Technical Memorandum

To: Bill Johnson, MDNR
From: Tina Pint and Jeré Mohr
Subject: Response to Cooperating Agency Comments Mine Site MODFLOW Model – Version 2
Date: July 7, 2015
Project: NorthMet EIS (23690862.00)
c: Jennifer Saran, PolyMet

Figure 3 Comparison of groundwater inflow rates to the mine pits during operations

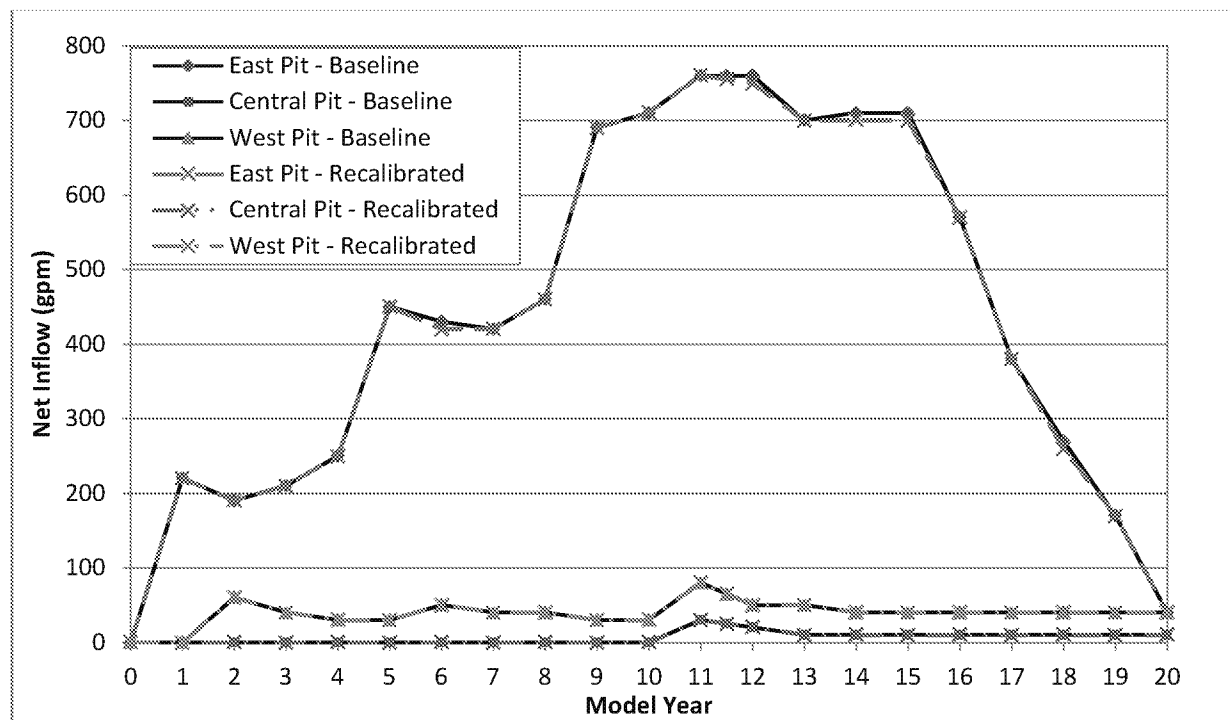
Concern has been raised on how the Partridge River is simulated in the MODFLOW model. Specifically, it was pointed out that in some cases, elevations used to simulate the river did not always result in a downstream decrease in river stage. The Partridge River is represented in the Mine Site MODFLOW model with the River Package, with the river cell stage used for the baseline MODFLOW model assigned from a digital elevation model (DEM). Given the differences in the scale of the DEM and the scale of the model cells, this methodology of assigning river stage did not always produce a downhill gradient between upstream and downstream model cells.

The recalibrated parameters and the new river package were imported into the Mine Site predictive models for operations and closure. As shown in Figure 3, the modeled pit inflows differed from baseline by a maximum of 2.9%, which is well within the limits of model accuracy. This sensitivity analysis demonstrates that the changes to the representation of the Partridge River in the model do not impact the model predictions of pit inflow.
